IAE Propulsion System - Nacelle **SERVICE BULLETIN**

Subject: Transmittal of Revision 1 to Service Bulletin Number V2500-NAC-36-0006

NACELLE - POWERPLANT - TUBES, PRESSURE INDICATING -
TUBE CLIPS - REPLACEMENT OF:

V2500-NAC-36-0006

REPLACEMENT OF SENSE TUBE 'P' CLIPS
FIGURE 1 SHEET 1

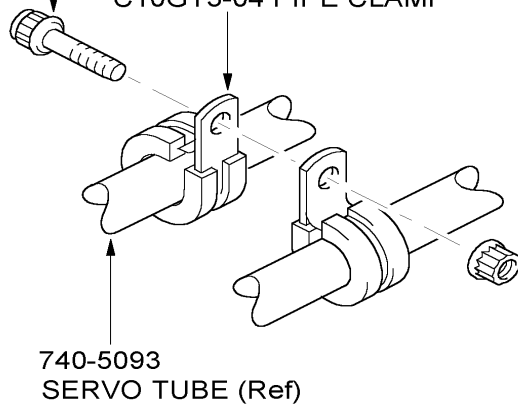
- (1) Remove the TAO25022FT04 'P' clip, AS21408 bolt and AS20624 nut from clipping point CP5864. Discard the 'P' clip. (Refer to Figure 1 sheet 1 and 2).

- (2) Install new C10GT3-04 'P' clamp and secure with the bolt and nut removed in previous step.
- (3) Remove the TAO25022FT04 'P' clip, AS21414 bolt, ST1698D-48 spacer and AS20624 nut from clipping point CP5907. Discard the 'P' clip.

REPLACEMENT OF SENSE TUBE 'P' CLIPS
FIGURE 1 SHEET 2

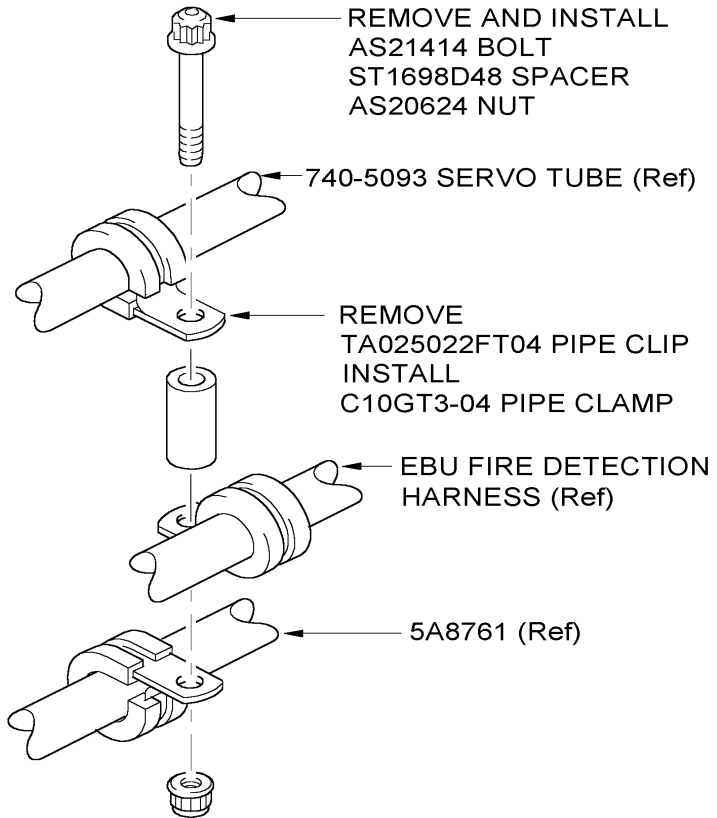
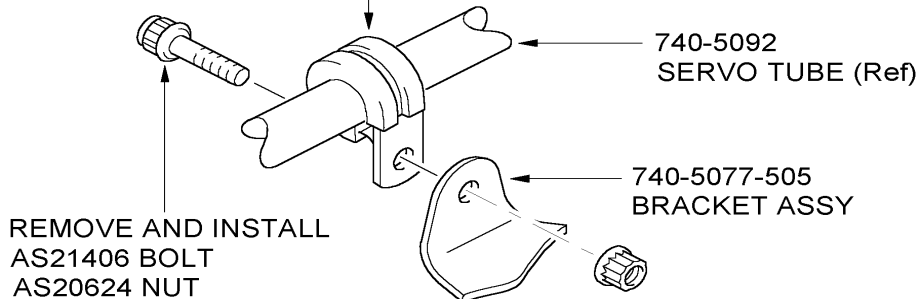
- (4) Install new C10GT3-04 'P' clamp and secure with the bolt and nut removed in previous step.
- (5) Remove the TAO25022FT04 'P' clip, AS21406 bolt and AS20624 nut from clipping point CP5867. Discard the 'P' clip.

REMOVE AND INSTALL
AS21408 BOLT
AS20624 NUT

REMOVE
TA025022FT04 PIPE CLIP
INSTALL
C10GT3-04 PIPE CLAMP

REMOVE AND INSTALL
AS21414 BOLT
ST1698D48 SPACER
AS20624 NUT

REMOVE
TA025022FT04 PIPE CLIP
INSTALL
C10GT3-04 PIPE CLAMP

REPLACEMENT OF SENSE TUBE 'P' CLIPS
FIGURE 1 SHEET 3

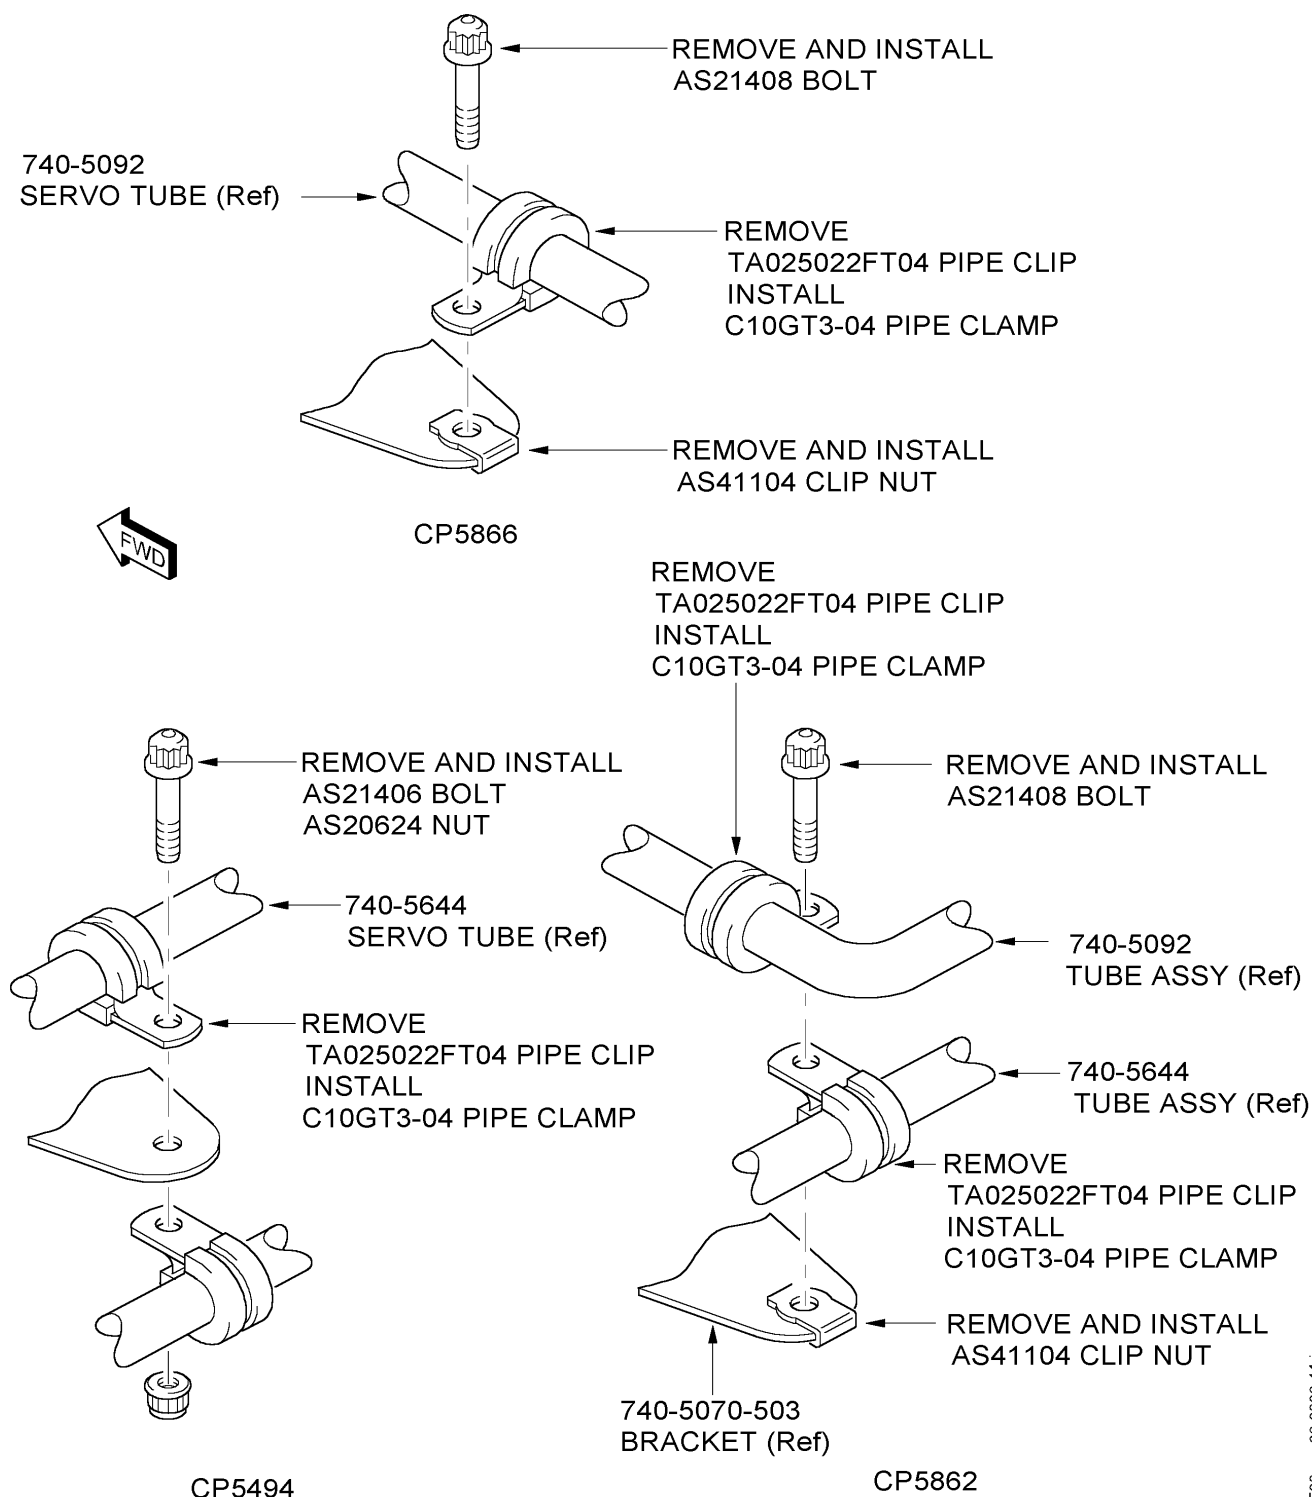
- (6) Install new C10GT3-04 'P' clamp and secure with the bolt and nut removed in previous step.
- (7) Remove the TAO25022FT04 'P' clip, AS21408 bolt and AS41104 clip nut from clipping point CP5866. Discard the 'P' clip. (Refer to Figure 1 sheet 3).

- (8) Install new C10GT3-04 'P' clamp and secure with the bolt and nut removed in previous step.
- (9) Remove the TAO25022FT04 'P' clip, AS21406 bolt and AS20624 nut from clipping point CP5494. Discard the 'P' clip.

REPLACEMENT OF SENSE TUBE 'P' CLIPS
FIGURE 1 SHEET 4

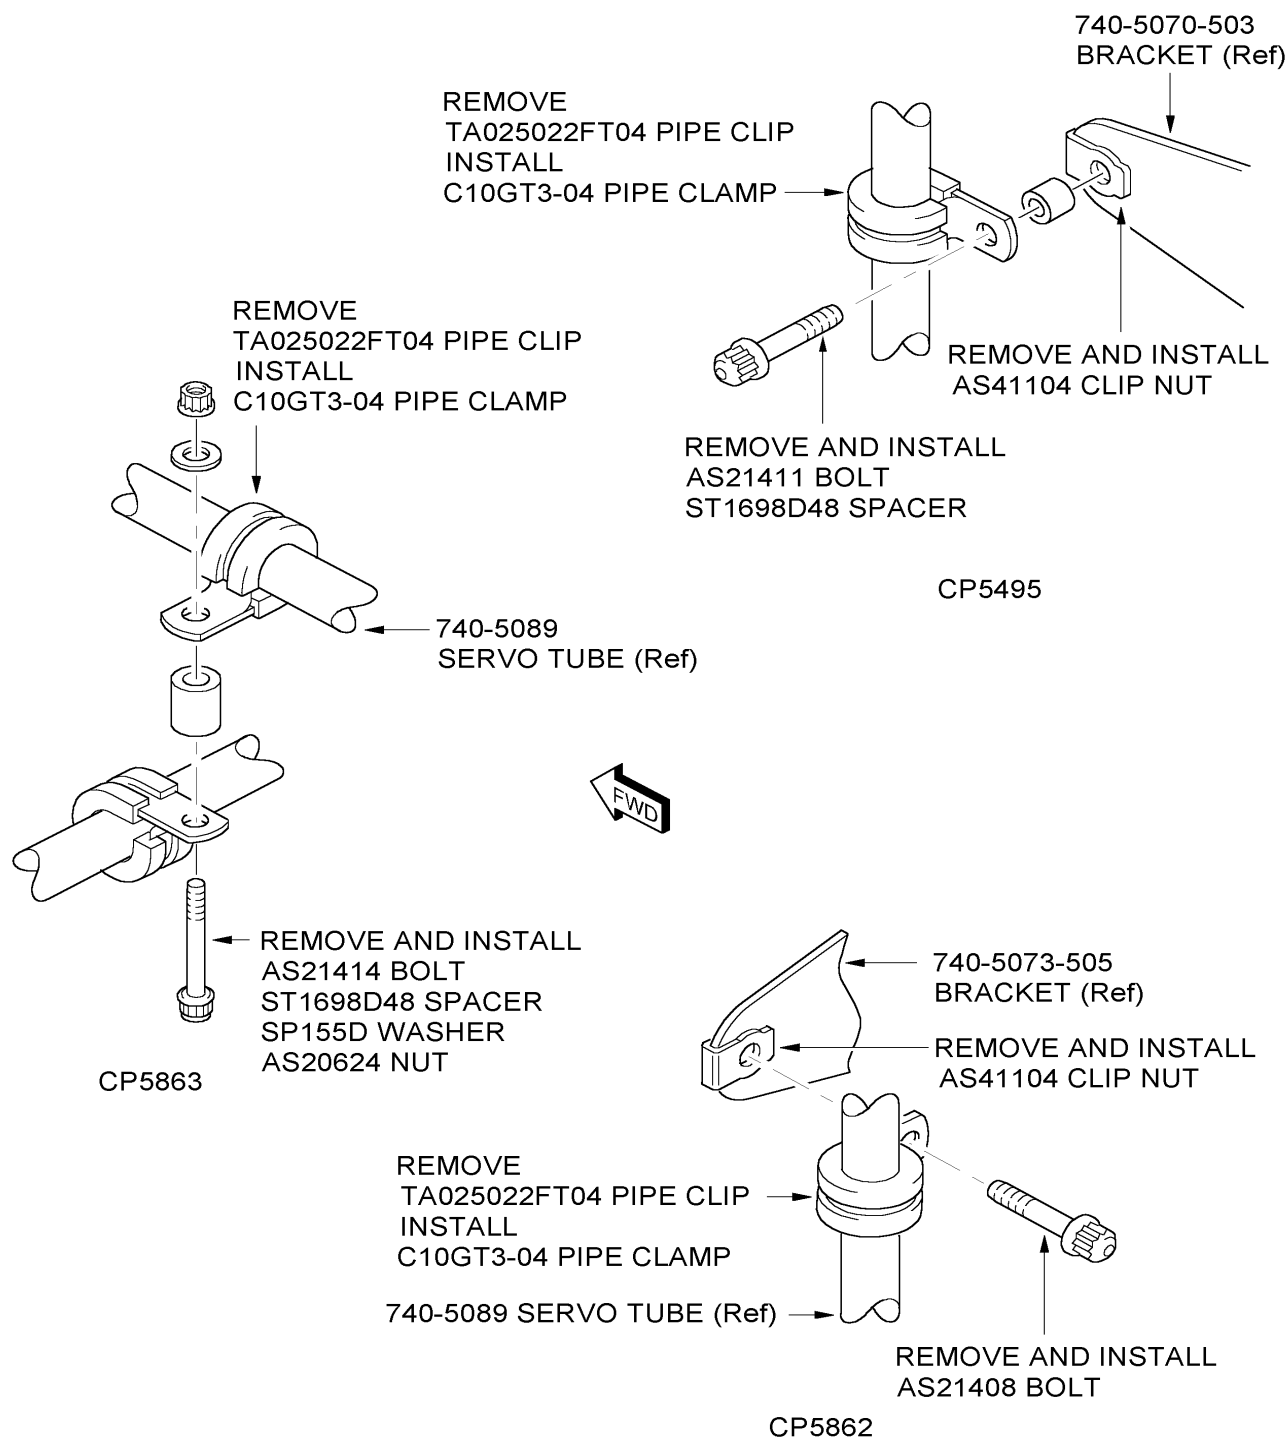
- (13) Remove the TAO25022FT04 'P' clip, AS21411 bolt, ST1698D-47 spacer and AS41104 clip nut from clipping point CP5495. Discard the 'P' clip. (Refer to Figure 1 sheet 4).
- (14) Install new C10GT3-04 'P' clamp, spacer and secure with the bolt and nut removed in previous step.
- (15) Remove the TAO25022FT04 'P' clip, AS21407 bolt and AS41104 clip nut from 740-5073-505 bracket at clipping point CP5862. Discard the 'P' clip.
- (16) Install new C10GT3-04 'P' clamp and secure with the bolt and clip nut removed in previous step.
- (17) Remove the TAO25022FT04 'P' clip, AS21411 bolt, ST1698D-48 spacer, AS20624 nut and SP155-D washer from clipping point CP5863. Discard the 'P' clip.
- (18) Install new C10GT3-04 'P' clamp, spacer and secure with the bolt, nut and washer removed in previous step.
- (19) Torque all the bolts to 40 lbf in (4.52 Nm).

REPLACEMENT OF SENSE TUBE 'P' CLIPS
FIGURE 2 SHEET 2

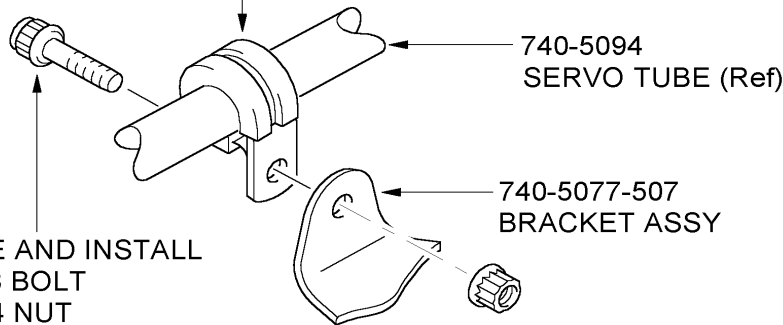
- (1) Do steps 2.B. (1) thru 2.B. (18).
- (2) Remove the TAO25022FT04 'P' clip, AS21408 bolt and AS20624 nut from clipping point CP5871. Discard the 'P' clip. (Refer to Figure 2 sheet 2).
- (3) Install new TA0210046FT04 'P' clamp and secure with the bolt and nut removed in previous step.
- (4) Torque all the bolts to 40 lbf in (4.52 Nm).

REMOVE
TA025022FT04 PIPE CLIP
INSTALL
C10GT3-04 PIPE CLAMP

REMOVE AND INSTALL
AS21408 BOLT
AS20624 NUT

REPLACEMENT OF SENSE TUBE 'P' CLIPS
FIGURE 3 SHEET 1

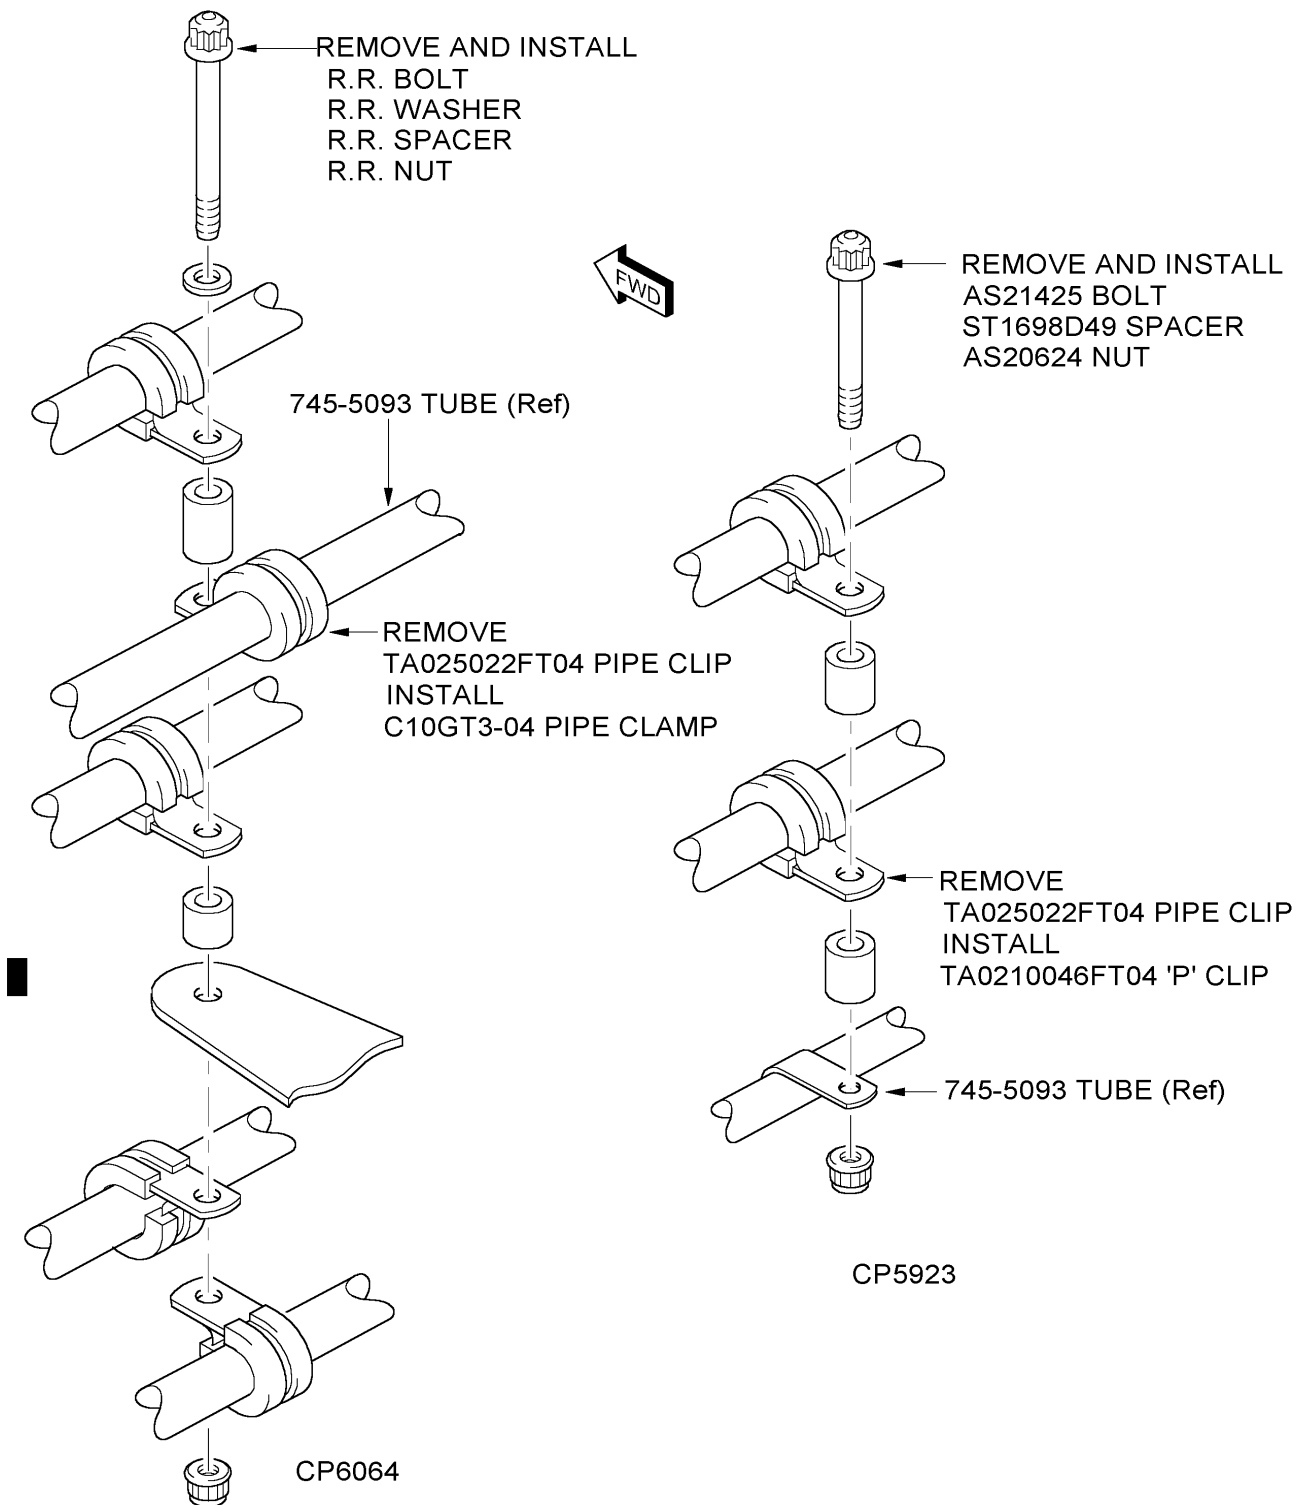
- (1) Remove the TAO25022FT04 'P' clip, AS21425 bolt, ST1698D-48 spacer, AS20624 nut and SP154-D washer from clipping point CP5923. Discard the 'P' clip. (Refer to Figure 3 sheets 1 and 2).
- R (2) Install new TA0210046FT04 'P' clamp, spacer and secure with the bolt, nut and washer removed in previous step.

REPLACEMENT OF SENSE TUBE 'P' CLIPS
FIGURE 3 SHEET 2

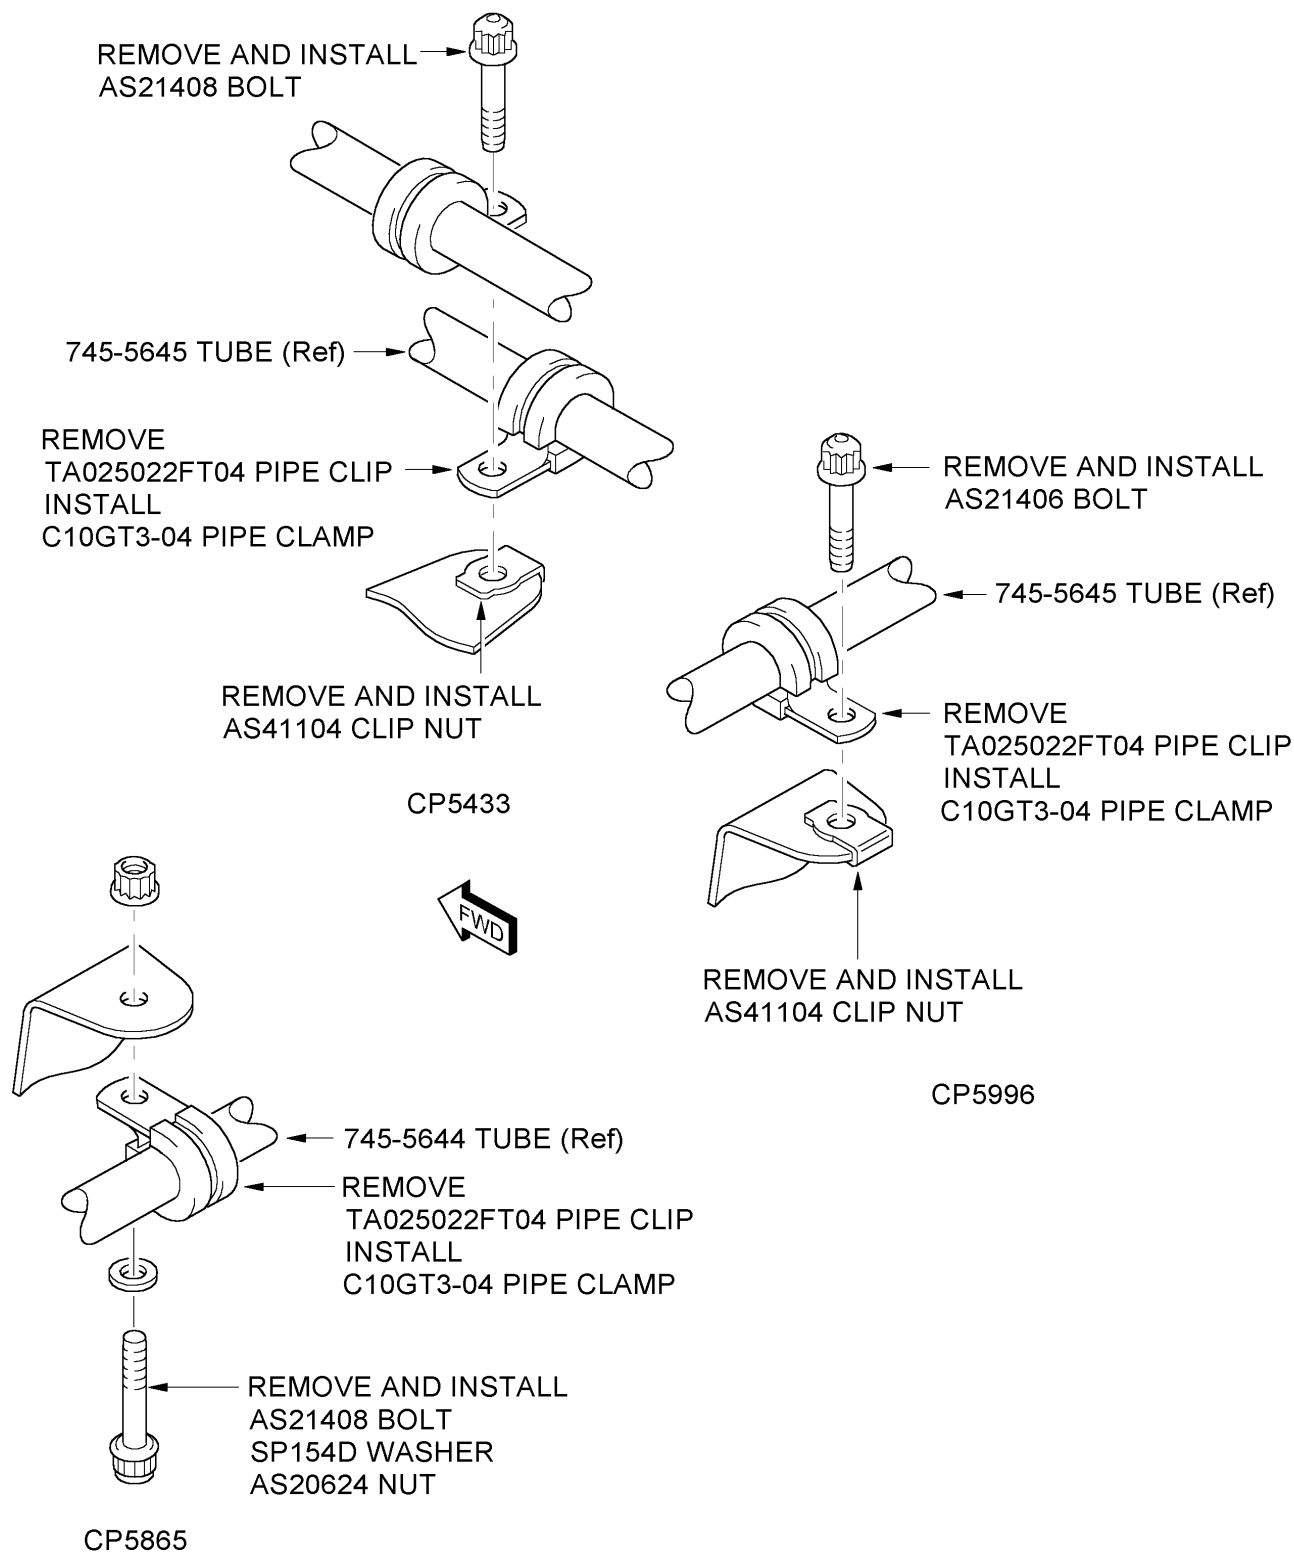
- (1) To amend "Internal Reference No" to include EC 96VN213A.
- (2) To amend Section 2, "Accomplishment Instructions" and Section 3, "Material Information" to include a new part number for the Sense Tube "P" Clip at clipping point CP5923.
- (3) To correct the Service Bulletin Number in Section 2 Part D "Recording Instructions".
- (4) To add the new TA0210046FT04 "P" Clip part number at CP5923 (Figure 3 Sheet 2).
